VILLAGE OF LOMBARD
INTER-DEPARTMENTAL REVIEW GROUP REPORT
ADDENDUM REPORT

SUBJECT: PC 22-05; 855 E. Roosevelt Road

LOCATION OF POSSIBLE 48-IN MINIMUM FENCE
(MEASURED ABOVE TOP OF CURB, IF NO CYPRESS)

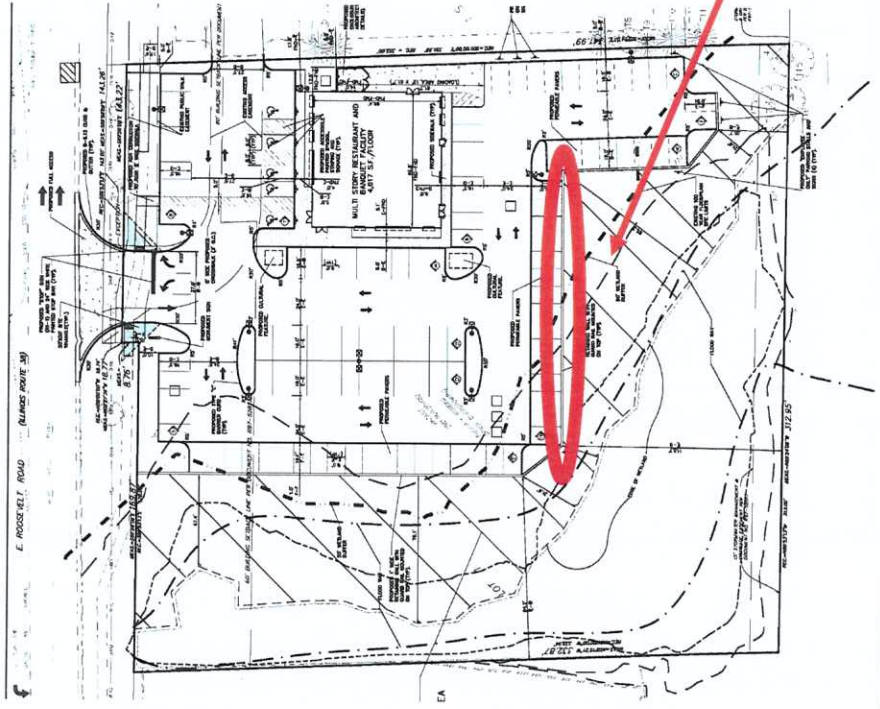
The petitioner also noted that the Plan Commission may place an additional condition of approval for a fence in lieu of the trees. Attached is an exhibit, provided by the petitioner, showing where a fence would go in lieu of the trees. A proposed condition of approval could read as follows, and would be made when making a motion of approval, should the Plan Commission proceed in that direction.

If DuPage County eliminates the bald cypress trees for screening, the petitioner shall place a 4' (four foot) tall fence for screening in conformance with the plan prepared by the petitioner.
